Interactive comment on “Behavior analysis by model slope experiment of artificial rainfall” by M. C. Park

Anonymous Referee #1

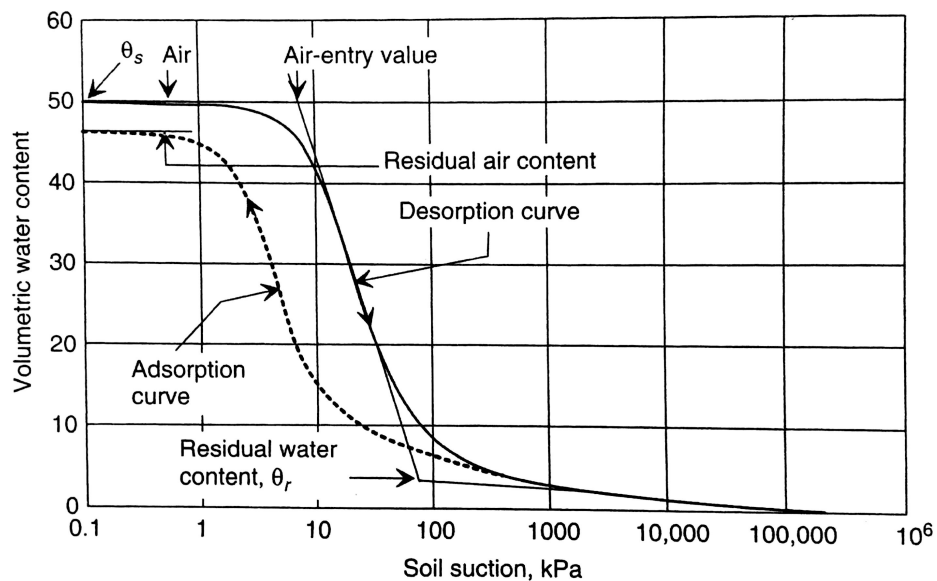
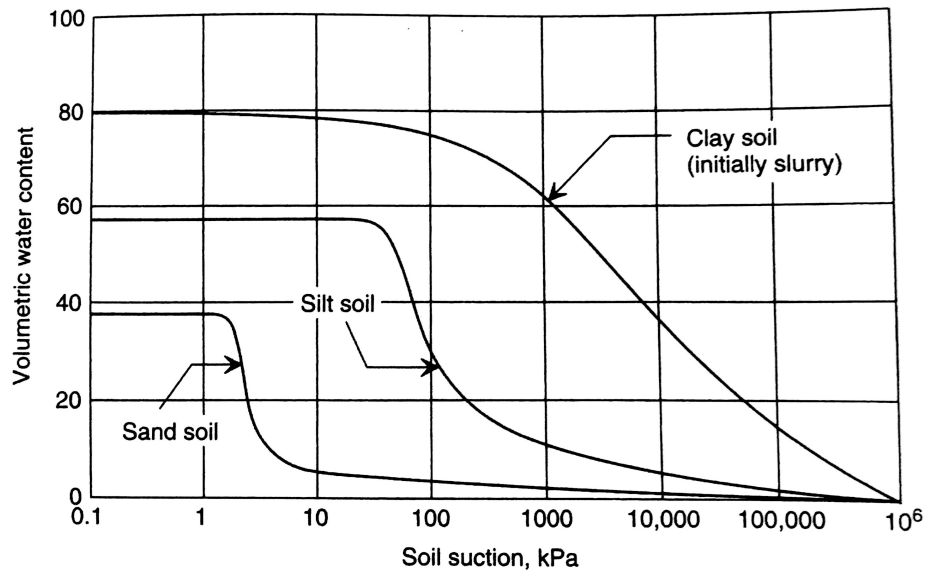
Question : The last point regards the interpretation of the soil parameters. The authors assign an air-entry value of 0.452, which is quite suspect. As far as I know, the air-entry value should be the point where air enters in the pore, i.e., the point where the curve deviates from the saturation. In the fitting of the data, this point is very close to the origin, which means that the material practically does not have any capillarity fringe (that is normal, indeed). Therefore, the air entry value should be low, almost 0, in my opinion.

- Answer : For seepage analysis, these are required the residual water content θ_r , the air entry pressure u_b , and the pore size distribution parameter n . The SWRCs were obtained from the pressure plate tests and fit to the van Genuchten model using the RETC code (Van Genuchten, 1980). Also, the air-entry value is also very similar compared to the figure below from the reference. It is a different value depending on the state of the soil, an air-entry value of 0.452 will not be a problem.
